UTAH Fashions Ltd. (Extension)

10th February 2021

PROJECT
AS BUILT 7 (SEVEN) STORIED
FACTORY BUILDING OF **UTAH FASHIONS LTD. UNIT 2**
AT SALNA, GAZIPUR, DHAKA, BANGLADESH

Retrofitting drawing cover-page, retrofitting column & footing schedule.

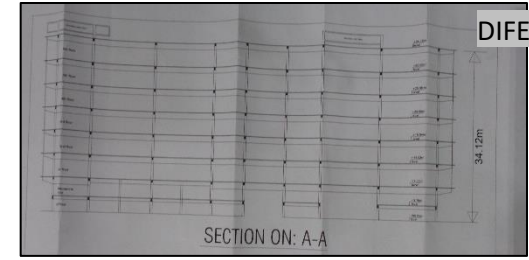
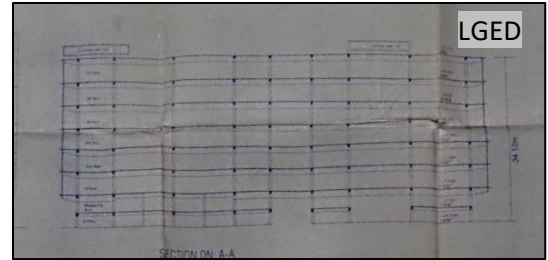
The building permission layout and drawing is for 8 storied structure. Also, the Detail Engineering Assessment (DEA) was prepared for the structure 8 storied structure where retrofitting has been suggested for footing, column and grade beam. Till the date of this inspection, Building was constructed up-to three storied. Hence, there is a possibility of future vertical extension. Also, factory authority verbally confirmed that they are intended to conduct vertical extension. Factory is required to submit the DEA documents to RSC for further review.

Column layout plan

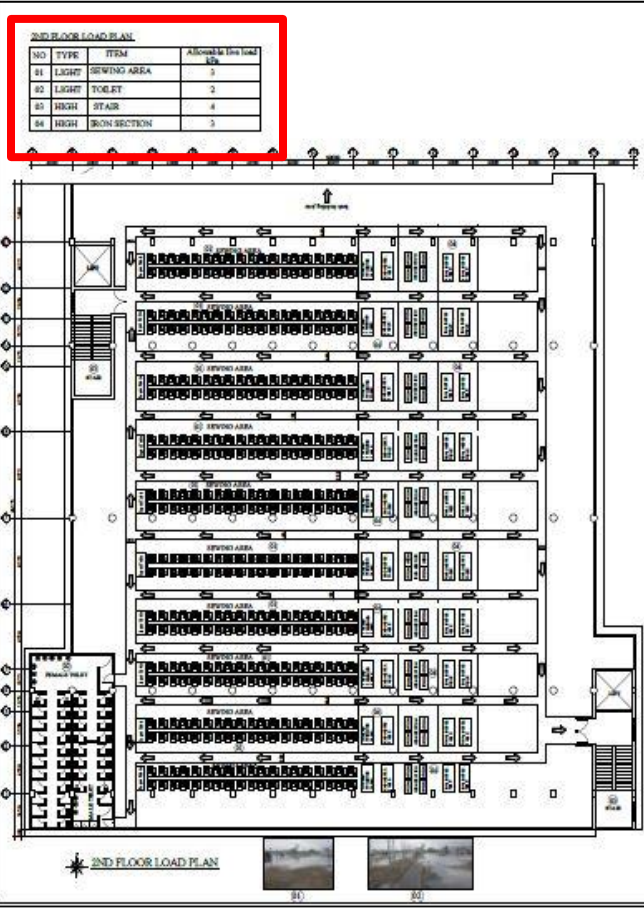
**Column to be stressed above normal design limit
considering possible vertical extension**

This building is permitted for 8 storied (G+7) storied from local authority. Currently, the building is three storied (G+2). Extended portion of column rebar was found at roof level which indicates the possibility of vertical extension.

Cursory calculation indicates that the marked columns are stressed above normal design limit considering prepared live load plan and equivalent concrete strength from concrete core test value for the 8 storied building.

The factory engineer is required to carry out a Detail Engineering Assessment considering BNBC 2006 provision prior to any extension work.

Overloading at Roof (3rd floor).

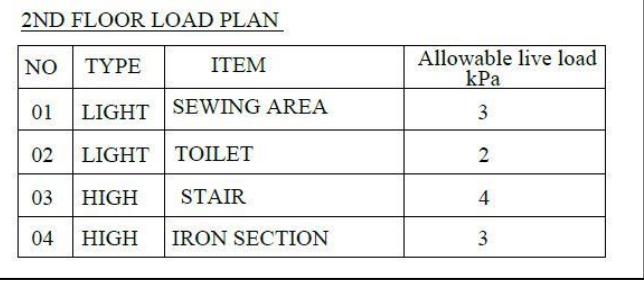
Uncontrolled loading was found at 3rd floor (Existing Roof) of the building due to stuck to the construction materials. Loading was found more than 3 kPa. Factory is required to maintain the floor live load within 3 kPa.

Corrosion in re-bar at roof

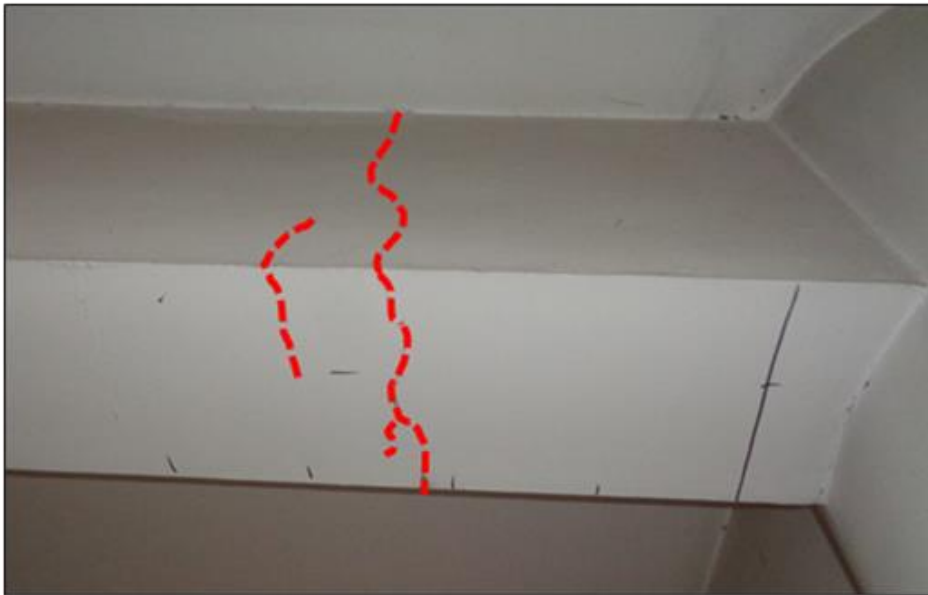
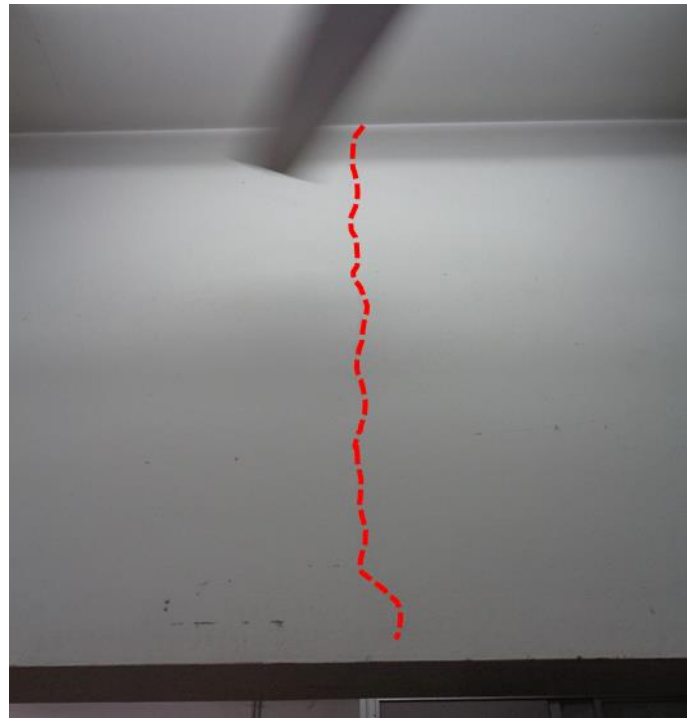
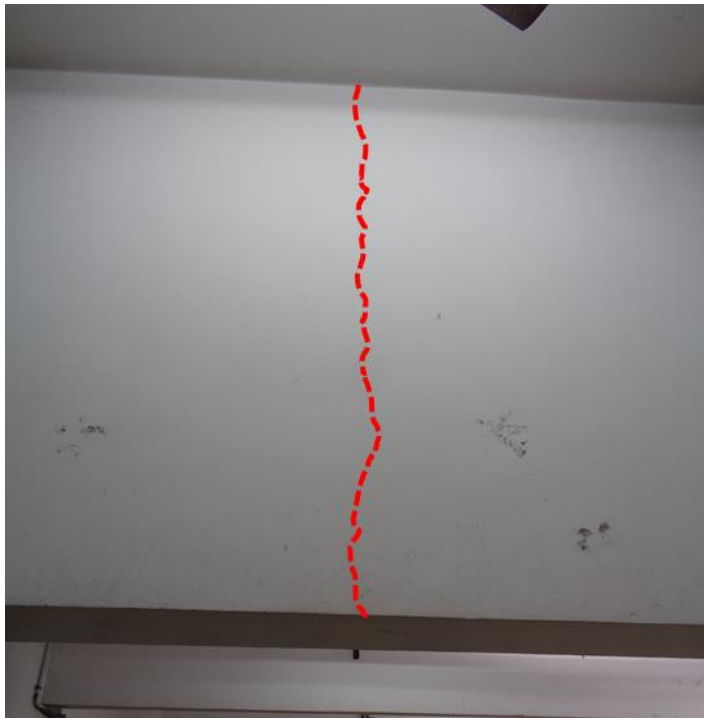
Column re-bar at roof exposed to environment for the further vertical extension of the building. Re-bar were found painted to prevent corrosion. But some of the re-bar were found corroded.

Factory is required to apply rust proofing on the corroded areas and do periodically maintenance to protect the re-bar from corrosion.
